DEVELOPMENT REVIEW BOARD  
SUPPLEMENTAL SUBMITTAL

PROJECT NO. PR-2020-004820

Application No. SI-2020-001468

**Re:** Hotel Circle Ramada Apartment Conversion DRB Update (PR-2020-004820)

**RAMADA INN CONVERSION**  
**BUILDING ENCROACHMENTS**

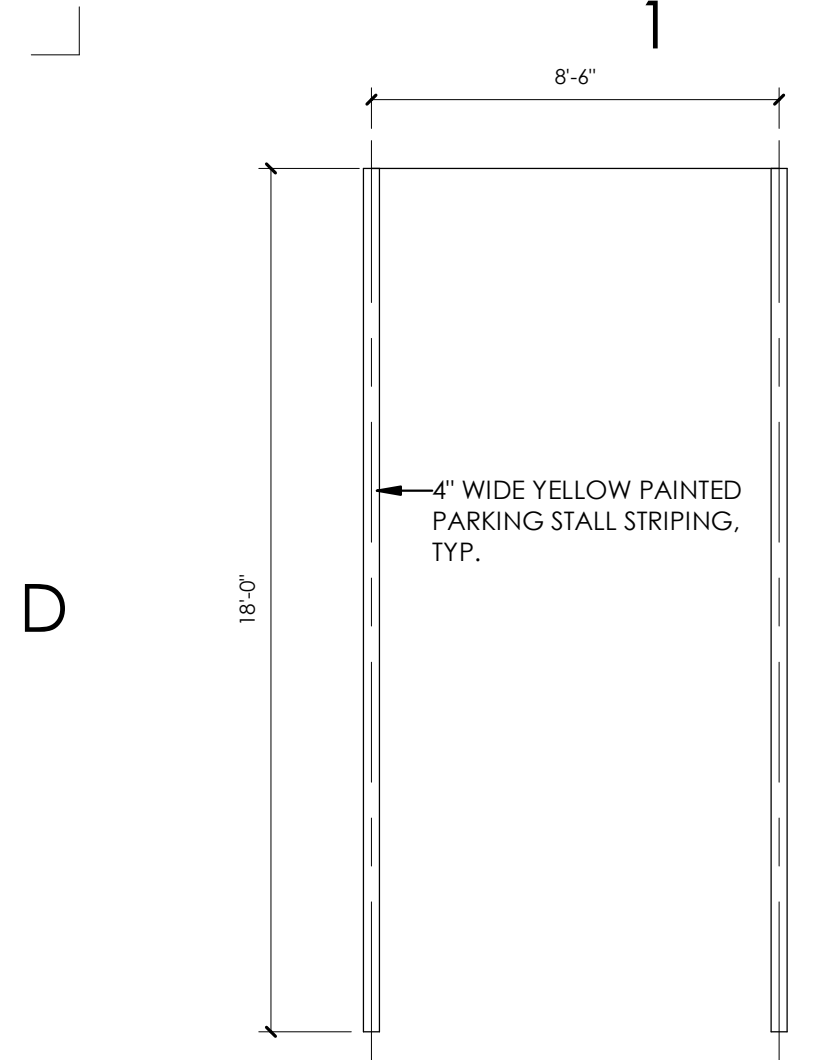
2. Building #6 appears to be encroaching into the existing 20' public waterline easement. This easement is for an existing 36" water transmission line which is critical infrastructure. Please provide a signed/stamped survey showing the location of the easement, existing waterline, and the encroachment of Building #6. Internal discussions with Legal will take place to determine what needs to take place.

- a. ***This encroachment appears to have existed for a very long time since development of the site approximately 50 years ago. Discussions are ongoing regarding the possible granting of additional easements opposite the encroachment to provide the minimum 20-foot clear easement for the Water Authority. An exhibit showing these encroachments and possible new easements is attached.***

**B1 SITE - TYP. FLARED ADA CURB CUT**  
1/4" = 1'-0"

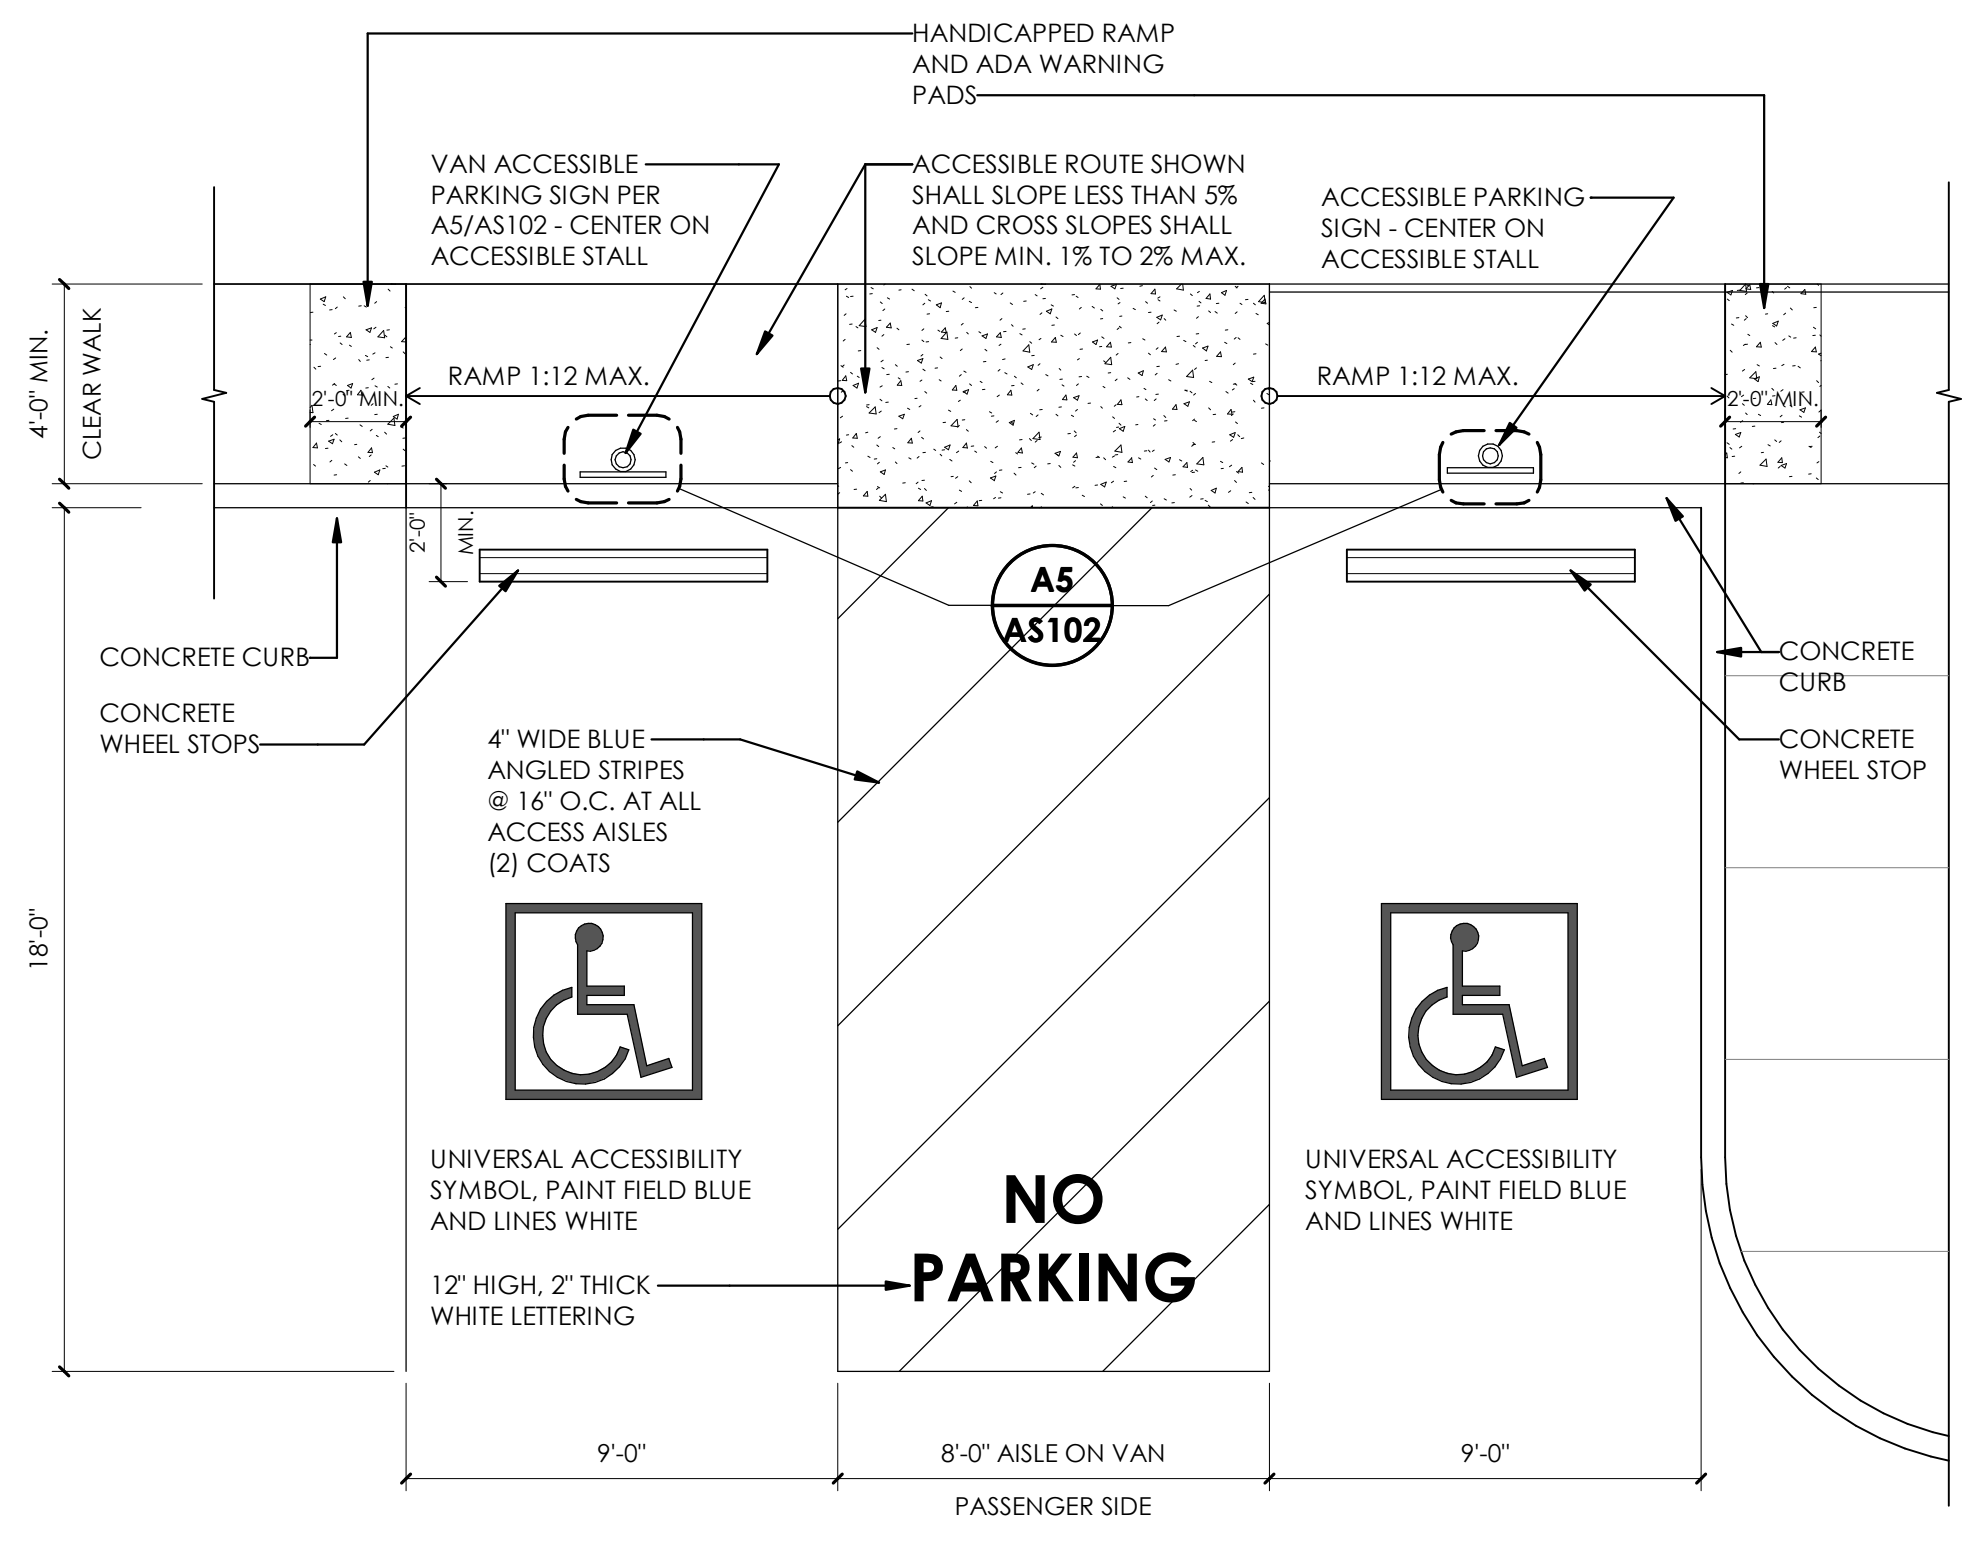
9. On the detail for the handicapped ramp that is perpendicular to the parking lot, show a minimum 4-foot pathway at the top of the ramp for turning a wheelchair. (Detail B1)

- a. ***The details have been dimensioned and updated with greater detail, as requested.***
10. Include a copy of the shared access agreement if it is available as indicated.

**A1 FIRE ONE PLAN**  
1" = 40'-0"

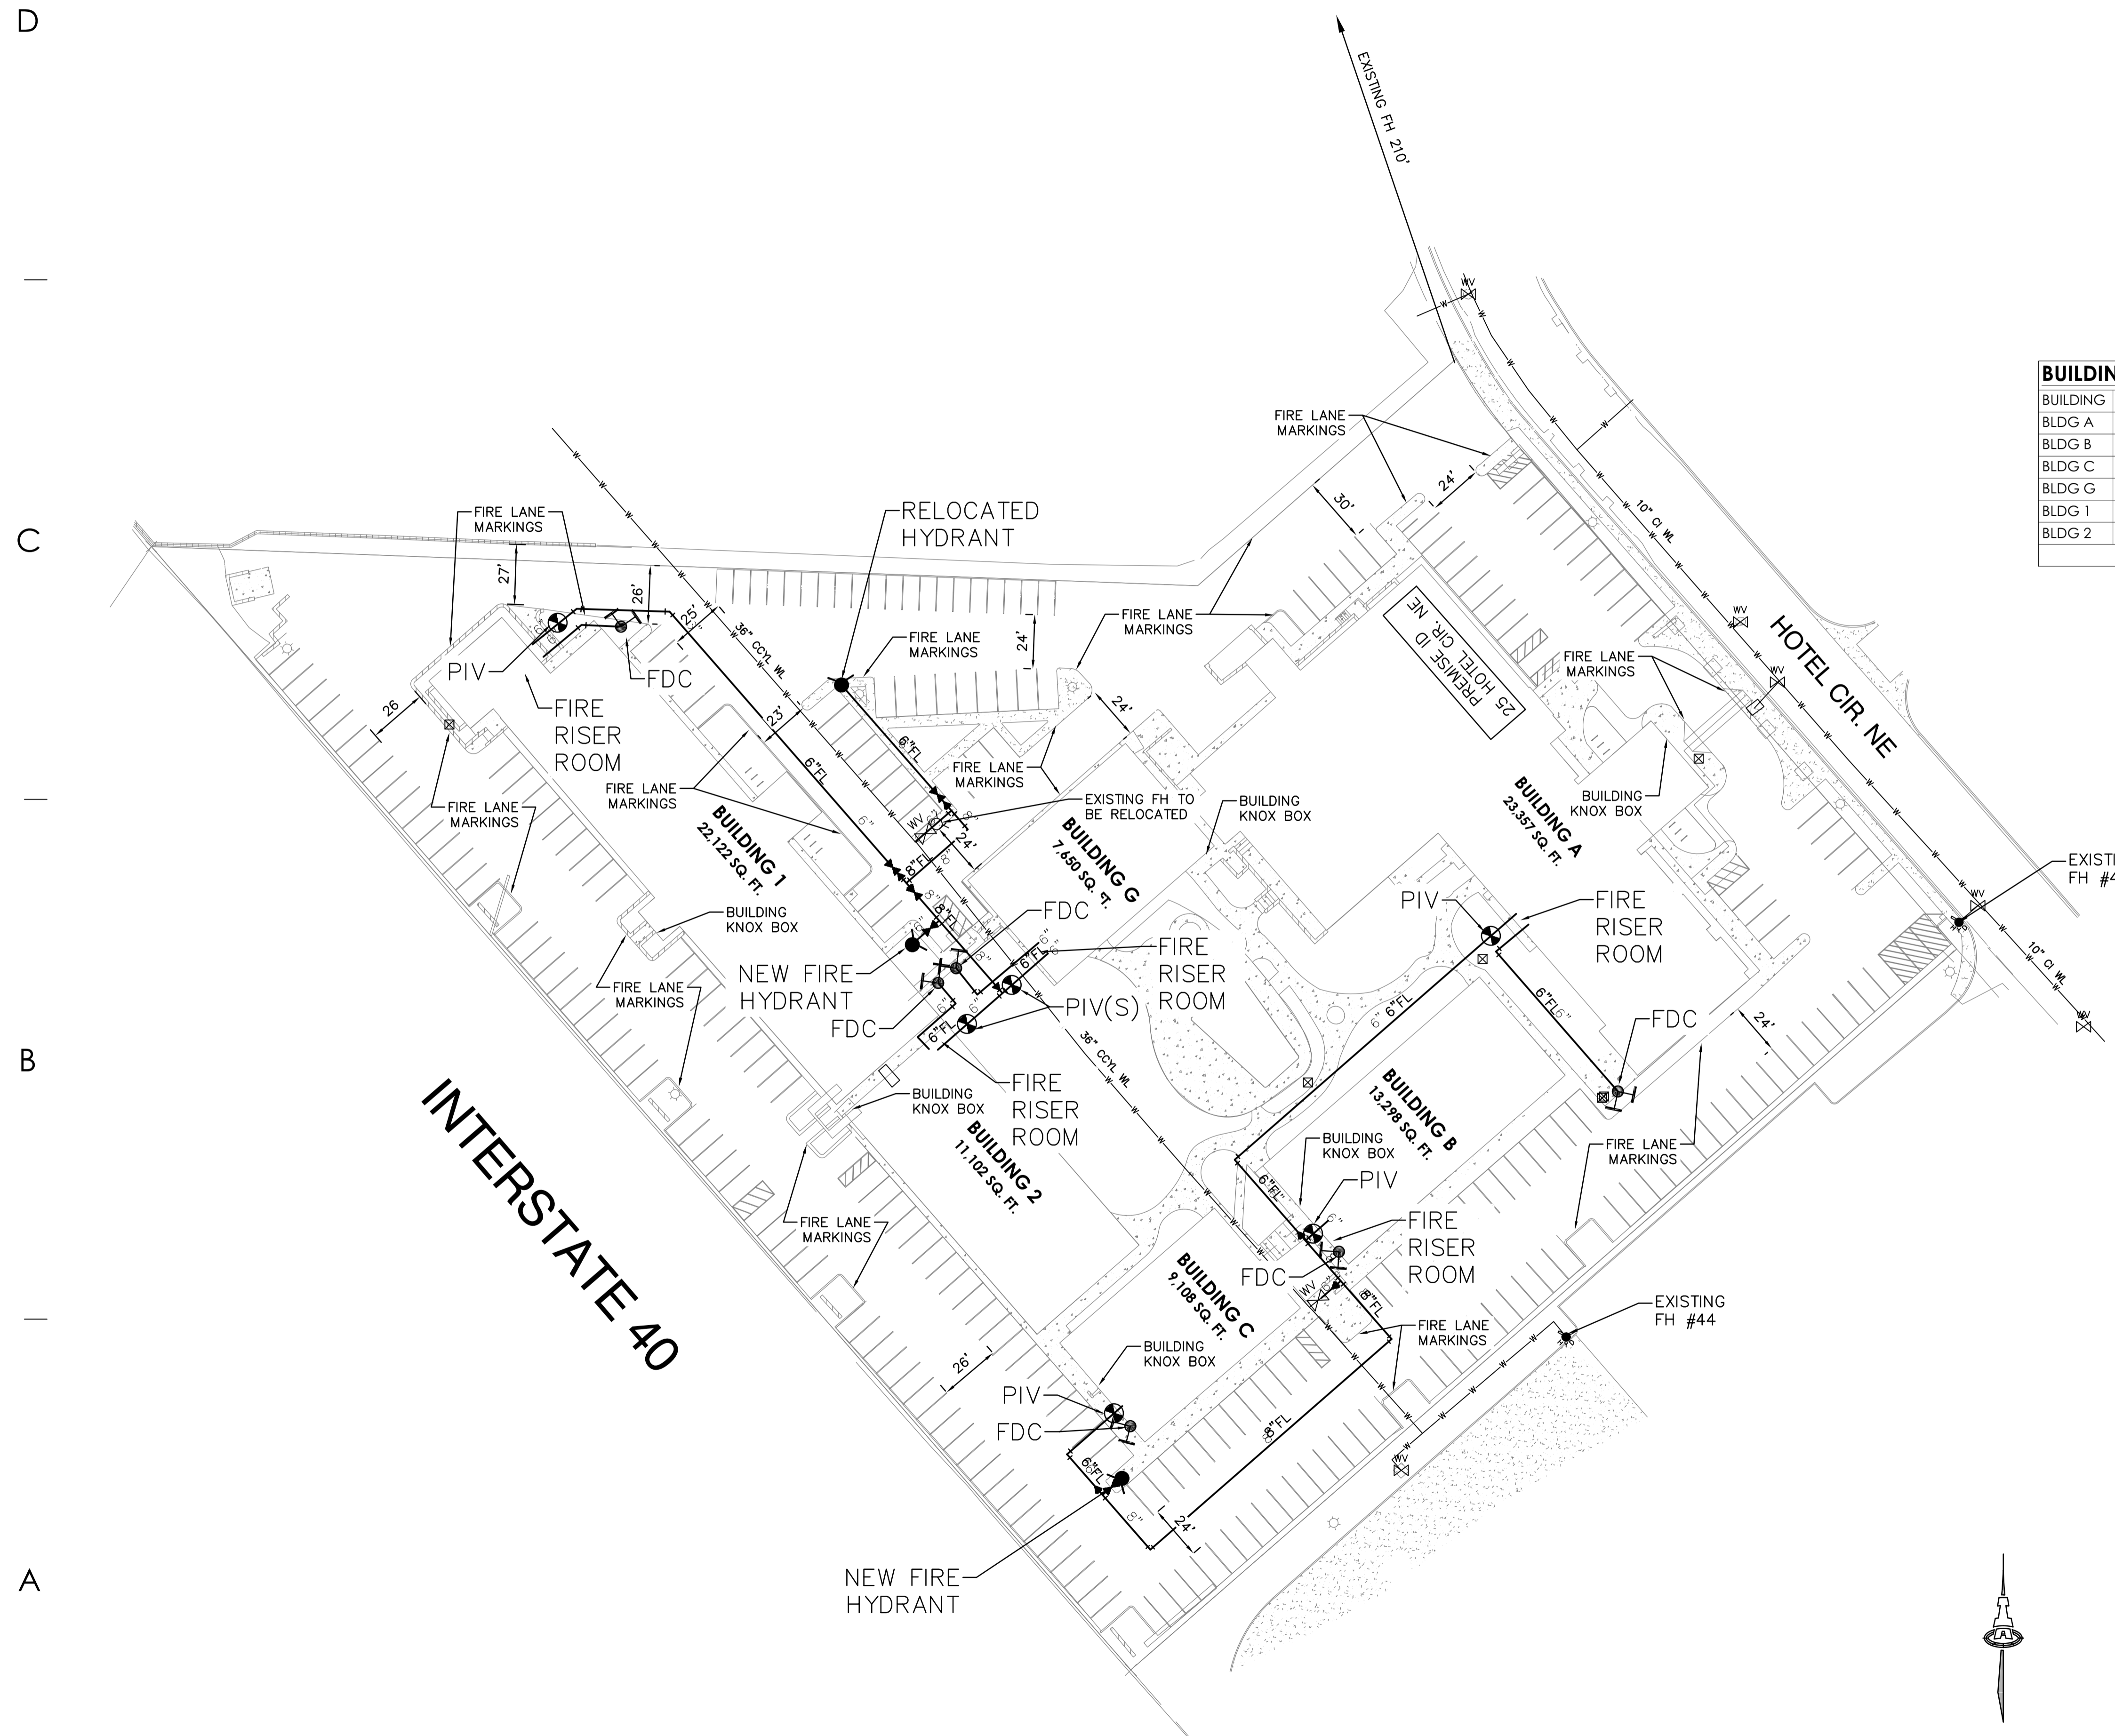
1. Availability statement #201213 is in holding as a fire one plan is required.
  - a. ***Understood. The Approved Fire 1 plan has been provided and is attached.***

- a. ***The approved Fire 1 plan is attached. The gates have been removed from the site plan at this time and will be evaluated later. It is understood an Amendment to the plan will be reviewed by the Fire Marshal and Transportation staff at that time.***
